Technical Advisory

TA-749-2

March 17, 2006

Installation of 4 pin processor fan heatsink connector on Intel® Server Boards SE7320SP2 and SE7525GP2 that have 3 pin fan headers

Figure 1. 3-pin and 4-pin heatsink fan connectors

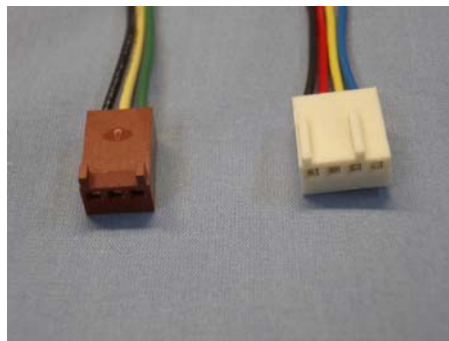
The 64-bit Intel® Xeon® processor with an 800-MHz system bus and 2 MB of L2 cache is shipping with a new heatsink fan that has a 4-pin connector (see figure 1 below). Processor heatsink fans are included only on the active boxed processor SKUs, passive boxed processor SKUs will continue to ship a heatsink with no fan. When integrating the Intel® Server® Board SE7320SP2 or SE7525GP2 into the Intel® Server Chassis SC5300, the passive version (no fan) of the Intel® Xeon® processor must be used. For integration into the Intel® Entry Server Chassis SC5275-E or instances where the server board is integrated into third-party chassis, the active heatsink solution may be required to meet the processor cooling requirements.

Figure 3: 4-pin fan connector plugged into 3-pin fan header and adjacent 6-pin fan header for Processor 2

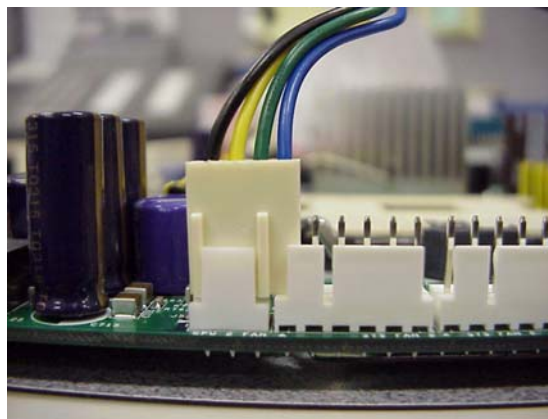
For processor 2, the PWM signal plugs into the adjacent 6-pin fan header. The pin the PWM signal plugs into is not connected on the server board, so this configuration will not damage the heatsink fan.

To install the 4-pin heatsink fan connectors onto the OEM 10-pack board's 3-pin processor fan headers, install the fan harness such that the pins 1-3 are inserted onto the header and pin 4 (PWM signal – blue wire) extends from the edge of the fan header or connects to the adjacent 6 pin fan header as described in this document.
